VT No. 32-2152

SERVICE BULLETIN

MILWAUKEE-EIGHT ENGINE - CRANKSHAFT POSITION SENSOR

Figure 1. New CKP Sensor

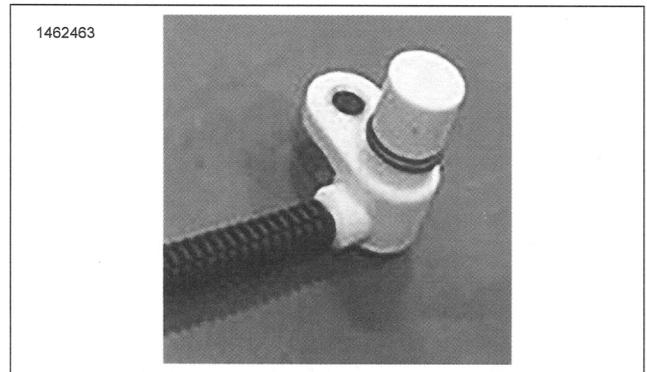
- See Figure 1. The CKP Sensor body is white in color.
- See Figure 2. Some discoloration (1) and sensor body doming (2) may be noted over time and occurs with engine heat cycles. This is not grounds for replacement or signs of a sensor defect.
- If a sensor is suspected of being defective, follow the diagnostic steps outlined within the Electrical Diagnostic Manual (EDM) for the appropriate model and model year of the vehicle being repaired.
